UNITED STATES PATENT AND TRADEMARK OFFICE

APPLICATION NO.	FILING DATE	FIRST NAMED INVENTOR	ATTORNEY DOCKET NO.	CONFIRMATION NO.
10/591,194	08/30/2006	Steven T. Peake	GB04 0052 US1	5898
65913	7590	04/03/2009	EXAMINER	
NXP, B.V. NXP INTELLECTUAL PROPERTY DEPARTMENT M/S41-SJ 1109 MCKAY DRIVE SAN JOSE, CA 95131			LEE, HSIEN MING	
			ART UNIT	PAPER NUMBER
			2823	
			NOTIFICATION DATE	DELIVERY MODE
			04/03/2009	ELECTRONIC

Office Action Summary	Application No. 10/591,194	Applicant(s) PEAKE, STEVEN T.	
	Examiner Hsien-ming Lee	Art Unit 2823

Fig 1

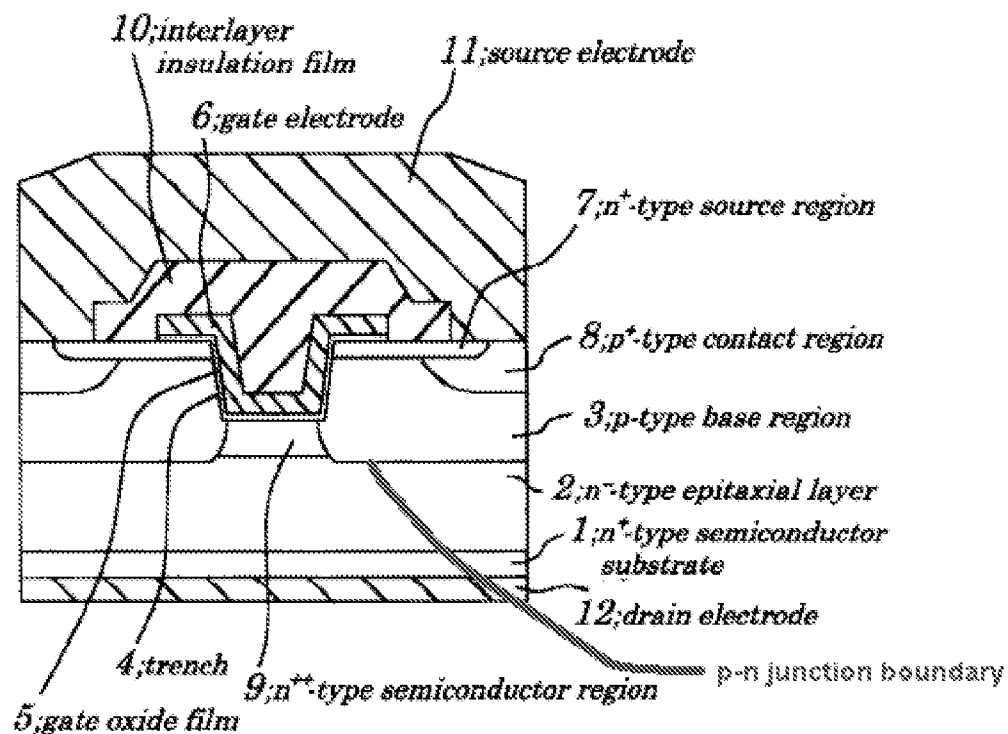
5. Claim 11 is rejected under 35 U.S.C. 102(b) as being anticipated by Yamada (US 6,160,288, submitted by applicant).

In re claim 11, Yamada, in Fig. 1 and corresponding text, a trench FET comprising :
a substrate 1 having a first major surface having a low-doped region
2 at the first major surface, the low-doped region 2 having a concentration of less than

$5 \times 10^{14} \text{ cm}^{-3}$ (i.e. from 10^{13} to 10^{14} , col. 9, lines 20-21) at the first major surface; a gate trenches 4 extending from the first major surface; a trench insulator 5 on the base and sidewalls of the gate trenches 4; a body region 3, a region 3, a, low-doped region 2 and a p-n junction between a body region 3 doped to have the second conductivity type (i.e. p type) above a drain region (col. 8, line 51) doped to have the first conductivity type (i.e. n type), the p-n junction being deeper below the first major surface between the trenches than at the trenches; and a source regions 7 at the first major surface adjacent to the trench 4.
